ADDENDUM #1

Project	Nelson H.S. Renovations	Project No.	2323
Location	4181 New Street, Burlington, Ontario	Date of Issue	2024 05 27
Owner	The Halton District School Board	File	2323/7.1.3

This Addendum forms part of the Contract Documents and amends the original Drawings and Specifications, dated 2024 05 13, as noted below.

Drawing Title:
**FIRST FLOOR PARTIAL
FLOOR FINISH PLAN &
ROOM FINISH NOTES**

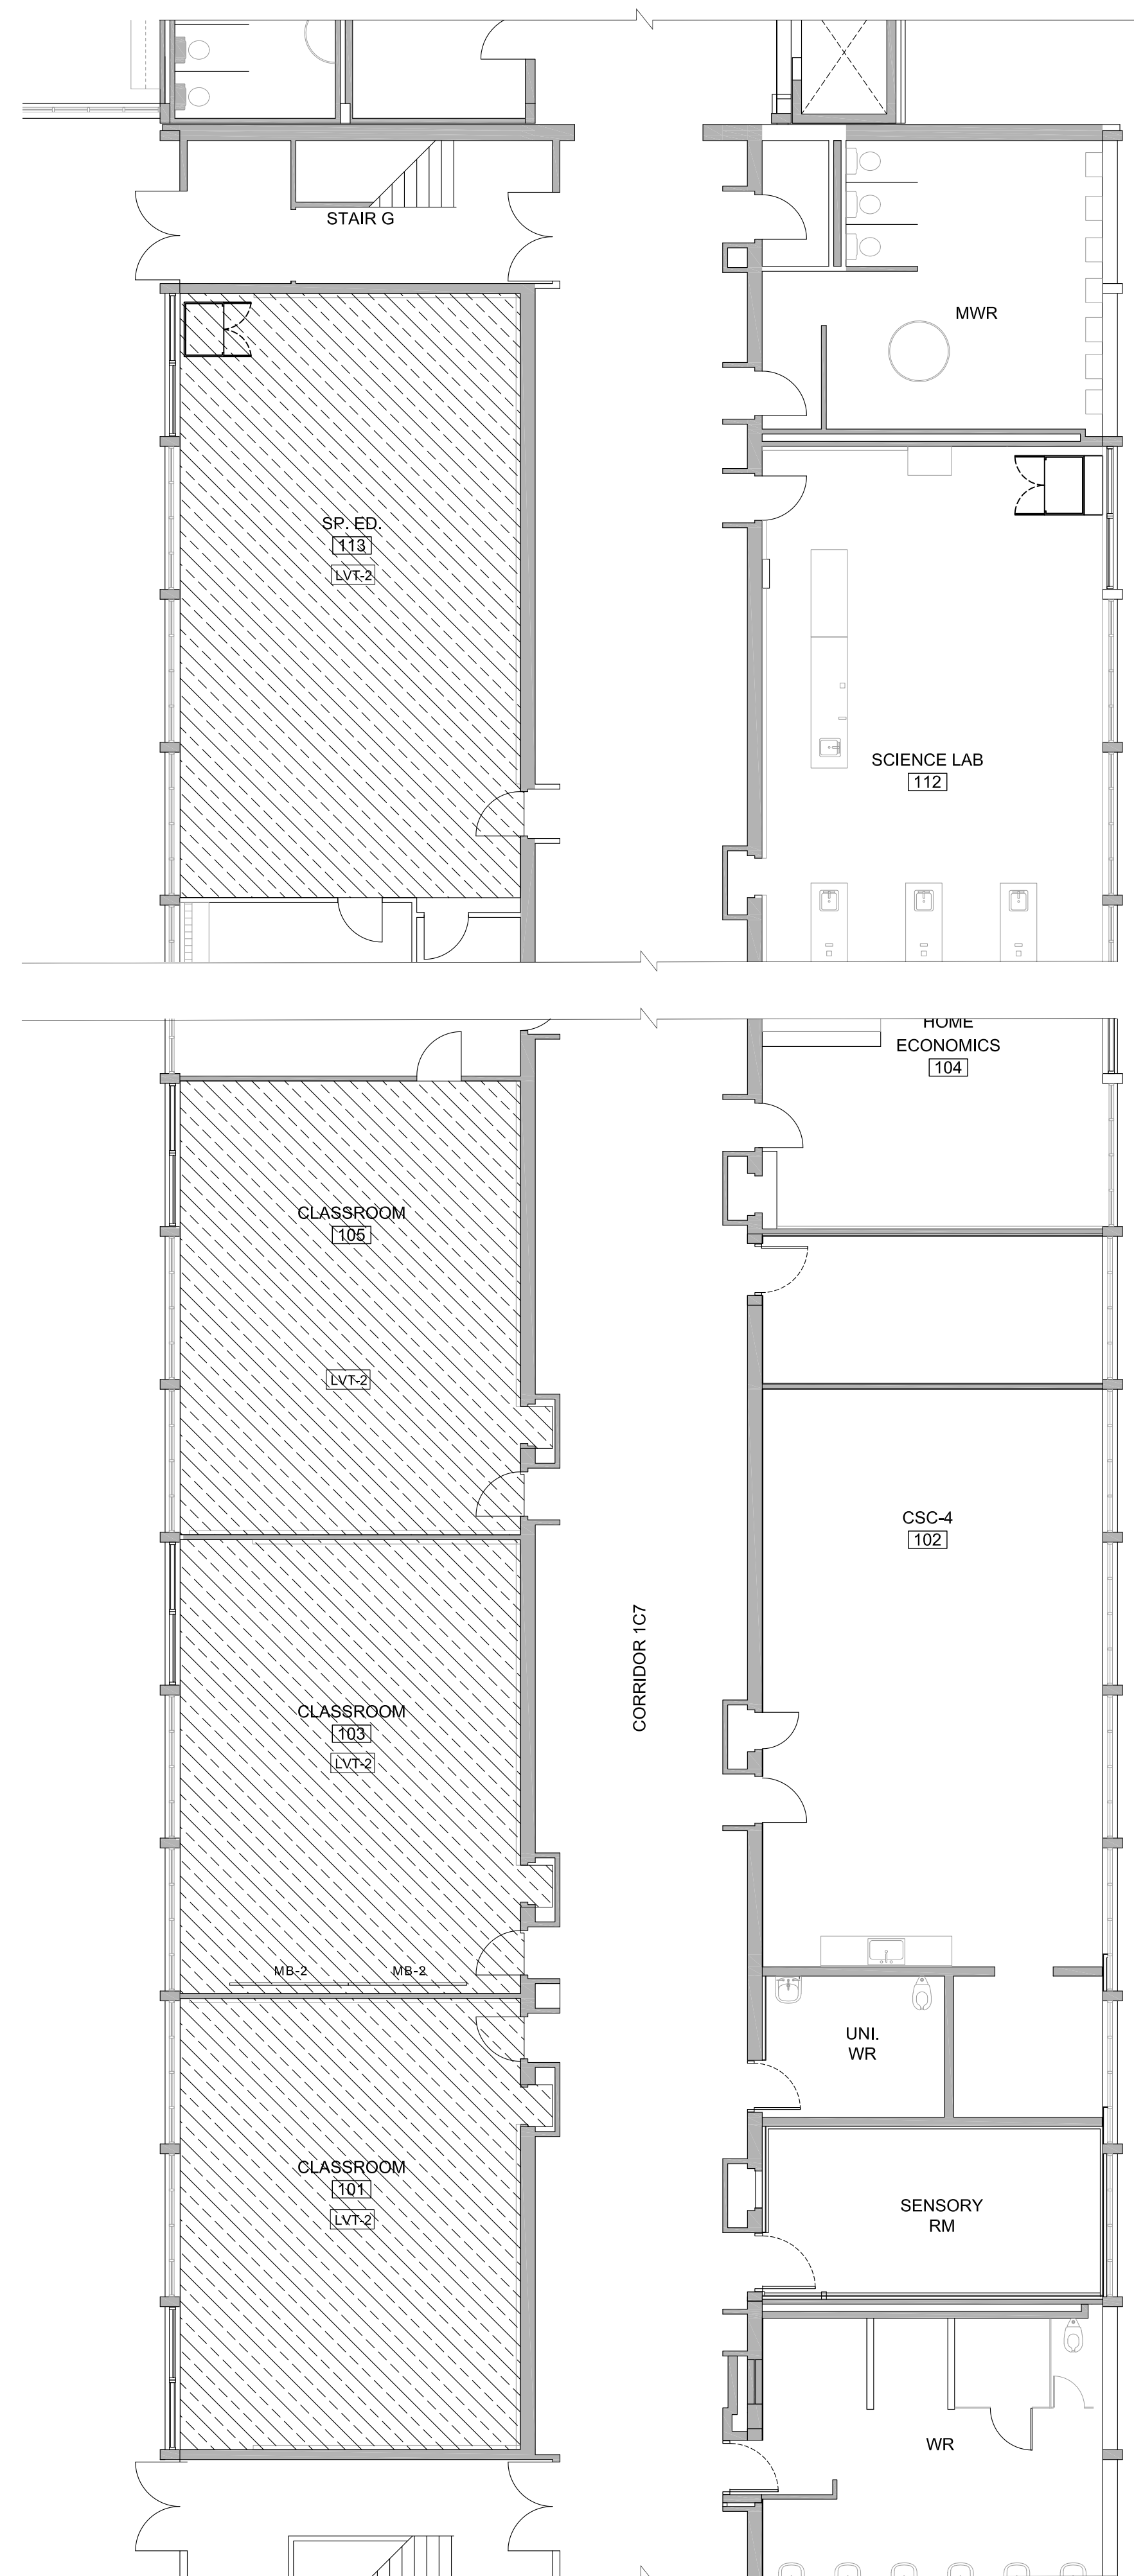
- .1 Room Finish Schedule : Replace ceiling finish for 1C6 and 1C7 as indicated
- .2 Room Finish Schedule : Replace notes for Room 102 CSC4 as indicated
- .3 Room Finish Schedule : Replace notes for Room 117 Family Office as indicated
- .4 Room Finish Schedule : Add notes for Room 106 Family Studies and Room 108 Science Lab as indicated
- .5 Add Room Finish Notes : 'PRIME AND PAINT ALL EXPOSED STRUCTURE, DUCTS, PIPES & CONDUITS IN ALL THE ABOVE LISTED ROOMS.'

NUMBER	ROOM NAME	WALL FINISH	CEILING FINISH
1C6	CORRIDOR 1C6	PAINT	EXST. ACT/NO PAINT
1C7	CORRIDOR 1C7	PAINT	EXST. ACT/NO PAINT
1	CLASSROOM 101	PAINT	PAINT
2	CSC4 - 102	PAINT	EXST. ACT/NO PAINT
3	CLASSROOM 103	PAINT	PAINT
4	HOME ECONOMICS 104	PAINT	PAINT
5	CLASSROOM 105	PAINT	PAINT
6	SCIENCE LAB 112	PAINT	PAINT
7	SPECIAL ED. 113	PAINT	PAINT
8	CLASSROOM 114	PAINT	PAINT
9	CLASSROOM 116	PAINT	PAINT
10	OFFICE 117	PAINT	PARTIAL NEW GB CELG/PAINT
11	CLASSROOM 118	PAINT	PAINT
12	SCIENCE LAB 119	PAINT	PAINT
13	CLASSROOM 120	PAINT	PAINT
14	FAMILY STUDIES 106	PAINT	PAINT
15	SCIENCE LAB 108	PAINT	PAINT

ROOM FINISH NOTES:
1. PRIME AND PAINT ALL EXPOSED STRUCTURE, DUCTS, PIPES & CONDUITS IN ALL THE ABOVE LISTED ROOMS.
